Yorkshire Green Energy Enablement (GREEN) Project

**Document 8.9.1 Applicant's Response to Examining Authority's First
Written Questions (ExQ1)**

**Final Issue A
April 2023**

Planning Inspectorate Reference: EN020024

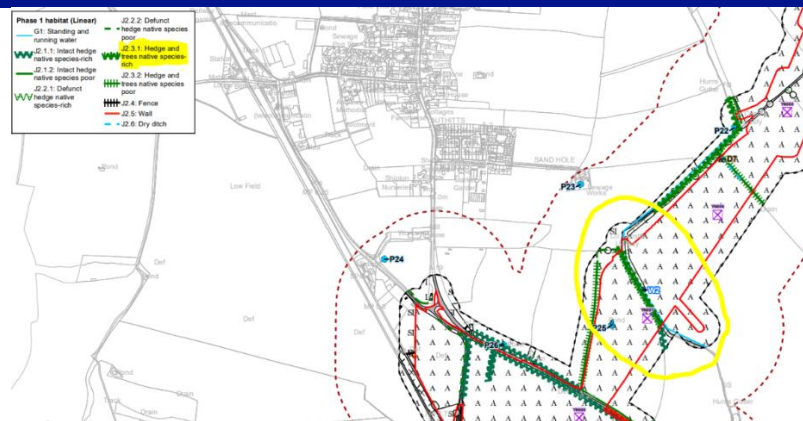
Q3.2.2	The Applicant	<p>Hedgerows: baseline assessment</p> <p>Para 8.5.34 of [APP-080] states that approximately 85,202 metres of hedgerow has been mapped within the Order limits during the Phase 1 Habitat Survey [APP-127] and also that there is approximately 29,566m of hedgerow within the Order limits.</p> <p>a) Can the Applicant clarify the discrepancy between these figures?</p>

<p>Applicant’s Response:</p> <p>a) The discrepancy in Paragraph 8.5.34 of ES Chapter 8 Biodiversity (Document 5.2.8 [APP-080]) is a typing error which has been included in the ES Errata Document to be submitted at Deadline 3. The corrected sentence should read as follows with the bold italicized insertion: ‘Approximately 85,202m of hedgerows have been mapped within the Order Limits <i>and 50m buffer</i> during the extended Phase 1 habitat surveys, of which approximately 29,566m are located within the Order Limits.’</p>
<p>Q3.2.3</p>	<p>The Applicant</p>	<p>Effects on hedgerows</p> <p>The Biodiversity assessment [APP-080] states that the Proposed Development is likely to result in a total permanent loss of approximately 953 metres of native hedgerows, with up to 17,036 metres of native hedgerow temporarily affected under a reasonable worst-case scenario.</p> <p>The Arboricultural Impact Assessment [APP-102], Table 1.12 states that the Proposed Development is likely to require the removal of 1,162 linear metres of hedgerow, with a further 3,392 linear metres of hedgerow “affected/managed” and 2,152 linear metres of hedgerow “potentially affected”.</p> <p>a) Can the Applicant supplement the justification in para 1.9.1 of [APP-102] and at footnote 132 of [APP-080] with further explanation as to the different survey methodologies used and why it considers these to be appropriate for establishing the baseline for the ES assessments.</p> <p>b) Do the Trees and Hedgerows Potentially Affected Plans [APP-050 – APP-055] derive from the data presented in the Biodiversity assessment or the Arboricultural Impact Assessment?</p> <p>c) Provide a single set of figures for the length of hedgerow that would be permanently lost and temporarily affected as a result of the Proposed Development.</p> <p>Applicant’s Response:</p> <p>a) The Arboricultural Impact Assessment (Document 5.3.3I [APP-102]) does not use Phase 1 habitat survey methodology to record and map hedgerows as detailed in Appendix 8B Extended Phase 1 Habitat Survey Report (Document 5.3.8 [APP-127]). Instead, the tree survey dataset was collected by arboriculturists following the principles of BS5837:2012 ‘Trees in relation to design, demolition and construction – Recommendations’, and may map a section of hedgerow (in Phase 1 habitat terms) as a combination of individual trees, hedgerows, groups or woodlands at the discretion of the surveyor and the level of detail applied in each situation. Thus, baseline hedgerow habitat is measured differently within the</p>

Ref No.	Respondent:	Question:
		<p>respective assessments. Habitat impacts are referred to in linear metres only in ES Chapter 8 Biodiversity (Document 5.2.8 [APP-080]), but include both canopy cover in m² (where full data on the area of a given section of trees, group or hedge is available) and linear metres (where data on the area of a given hedge feature is unavailable) in the arboricultural assessment as stated in paragraph 1.8.8 of the Arboricultural Impact Assessment (Document 5.3.3I [APP-102]).</p> <p>An example is included below to illustrate where a hedgerow with trees surveyed to BS5837 consists of a range of tree feature types including individual trees, tree groups and hedgerows. This same feature is classed as a single hedgerow in the Biodiversity Assessment. Below are extracts from (in order of the images):</p> <ul style="list-style-type: none"> • Sheet 3 of the Tree Constraints Plan, Annex 3I.1 of the Arboricultural Impact Assessment (Document 5.3.3I [APP-103]) - this shows trees recorded as groups (G reference), hedges (H reference) and individual trees (T reference), it also shows where extended Phase 1 habitat data has been used to cover sections of low growing hedgerow that weren't recorded by the tree survey (shown as a purple line):
